DS #: 5222

PROJECT: Summerlin Village 21B Crystal Canyon Parcels A and B

CITY OF LAS VEGAS		DATE:
INTER-OFFICE MEMORANDUM		December 23, 2019
TO: Land Development Services Department of Building & Safety		FROM: Jennifer Shinn, P.E.  Flood Control, Engr. Associate Department of Public Works
SUBJECT:	Drainage Study for:	COPIES TO:
	Summerlin Village 21B Crystal Canyon Parcels A and B	RCI Engineering
Cross Streets:	Carriage Hill Drive and Far Hills Avenue	Woodside Homes of Nevada, LLC
File Number:	F:\Depot\DSMemos\DS05222A.doc	Bart Anderson, P.E., DevCo
Parcel Number:	137-26-212-001, 137-26-212-002	CCRFCD
Zoning Action:		
FEMA Flood Zone	YES NO X	
Proposed Storm Drain	YES X NO

The Drainage Study for the subject project has been reviewed and:

FIGURE 5
INTERIM PHASE 1

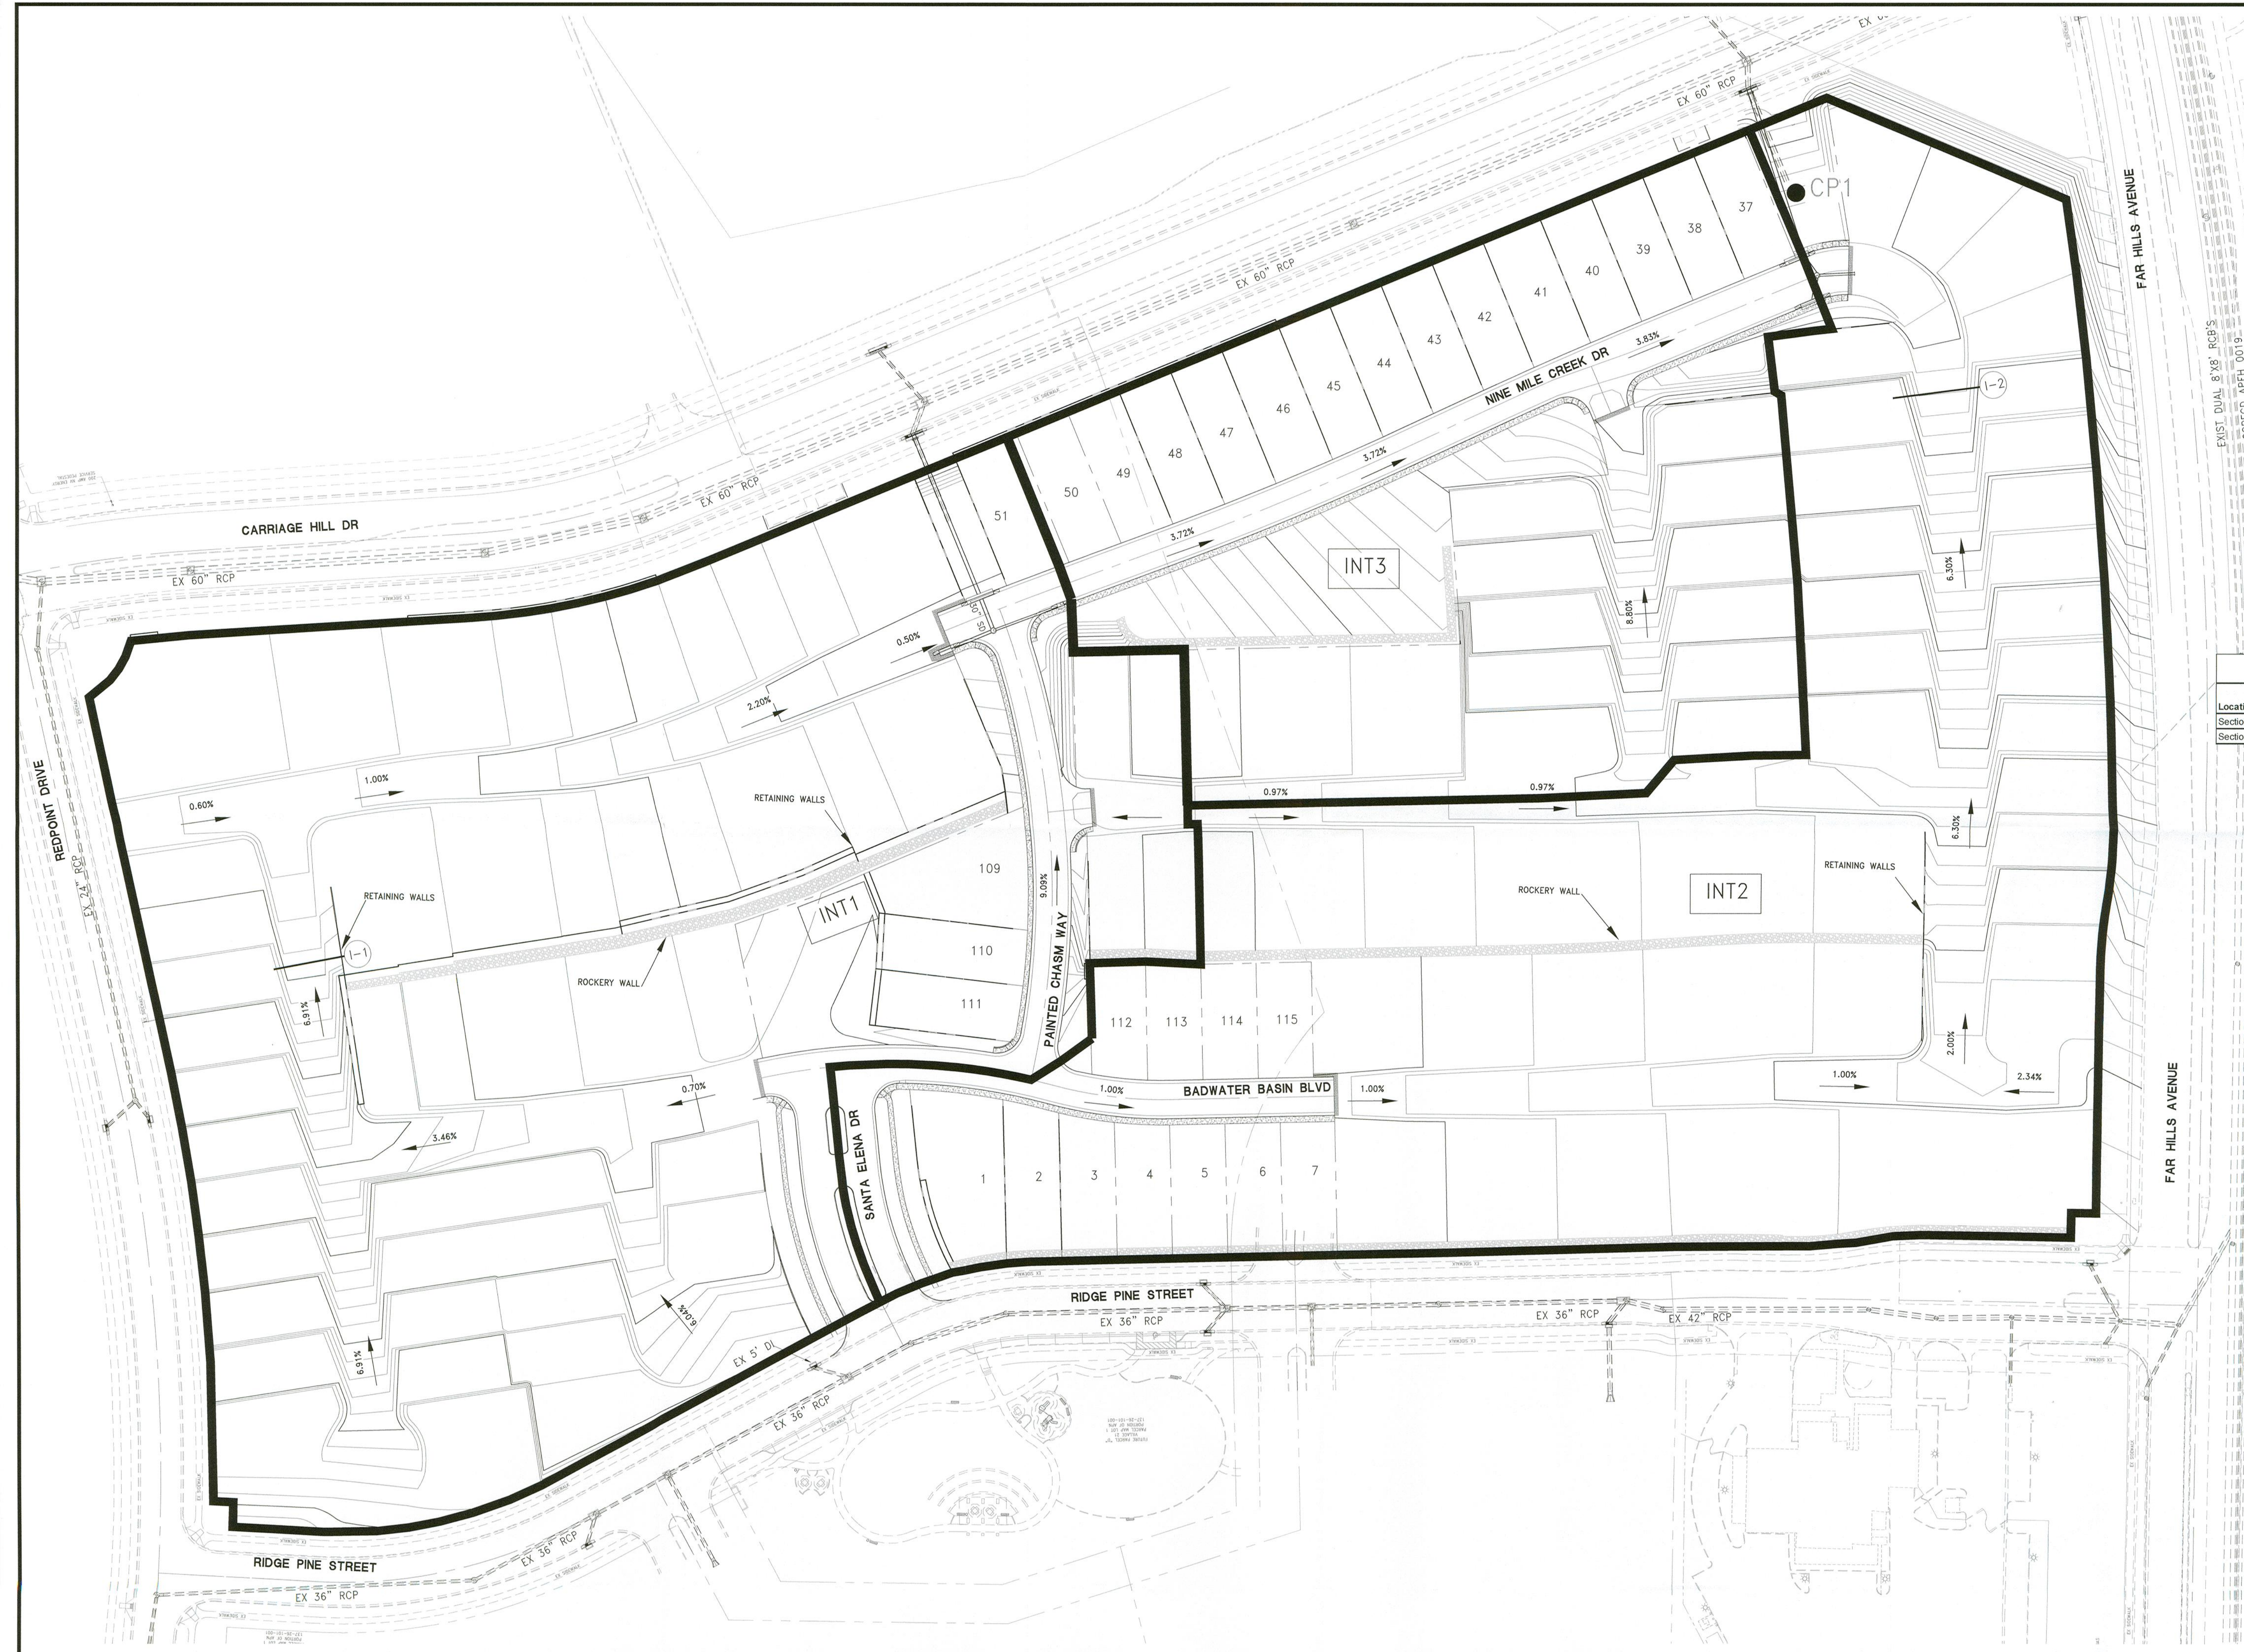
8. Interim Flow Hydraulic Analysis Report calls out "DI 1-2 sump interim" however Figure 5 Interim Phase 1 shows 4 inlets, none of which are labeled. Provide inlet labels on Figure 5 and provide calculations for all proposed inlets in the interim condition.
